V2500-A1 SERIES PROPULSION SYSTEMS SERVICE BULLETIN

This document transmits the Initial Issue of Service Bulletin V2500-ENG-72-0595.

ENGINE - LP COMPRESSOR - DELETION OF SCREENS OF THE LPC BLEED DUCT ASSEMBLY

Screen Assembly of LPC Bleed Duct Assembly - Before and After Modification Figure 1

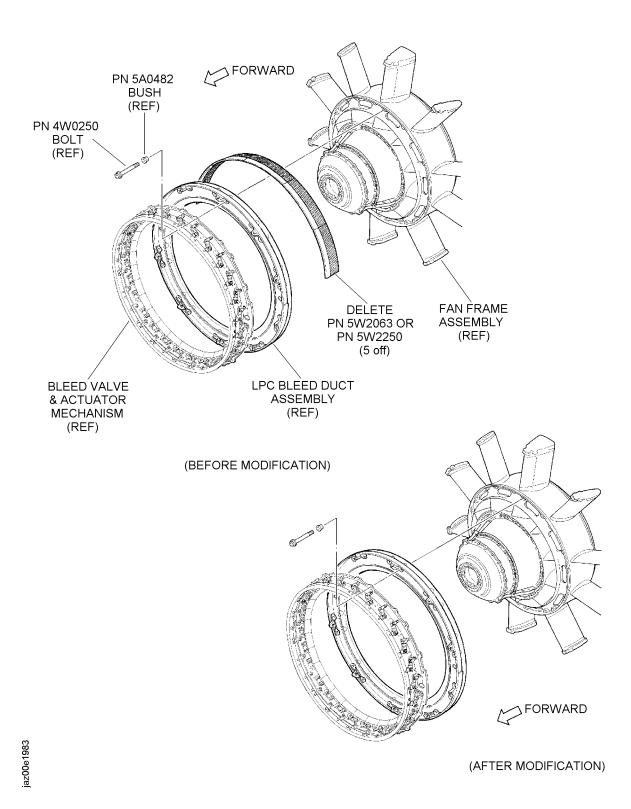
Material for the frame and mesh in the screen assembly on the V2500-A1 engine will not be available in the future. The original material is no longer available and while researching and testing alternatives, IAE found the screen was not necessary so IAE are deleting the part.

The screen assembly has been deleted.
